TECHNICAL BULLETIN

MODEL/DERIVATIVE:
Discovery Series II

Bulletin N°: 0072
CDS. ref: L8671bu
Issue: 1
Date: 04.07.01

GLOVE BOX WILL NOT STAY CLOSED

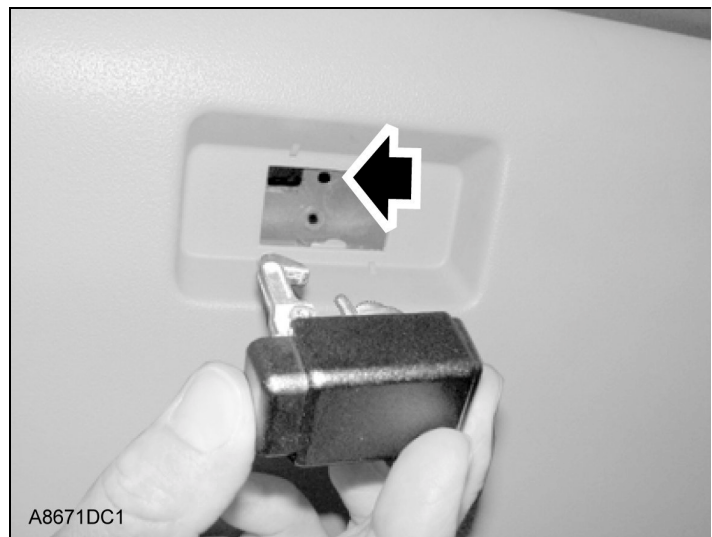
The customer complains that the glove box will not stay closed and / or that it is difficult to close and rattles.

Oversize location hole for latch assembly alignment pin allowing latch to rotate, resulting in misalignment of the latch to the striker.

1. With the glove box open, using a short screwdriver, remove the single countersunk screw securing the latch assembly to the glove box.
2. Identify the hole in the glove box for the latch location pin, (arrowed in illustration).
3. Apply 'Loctite Super Glue Gel' or 'Loctite Super Attack' to the location hole.

4. Refit the latch assembly ensuring that it is aligned squarely with the moulded recess in the glove box. Tighten the securing screw to a torque of 1Nm.
5. Confirm that latch assembly is square to the glove box and operates freely, with the latching pawl returning fully to its rest position.
6. Allow a minimum of 5 minutes for adhesive to cure before testing the glove box for satisfactory operation.
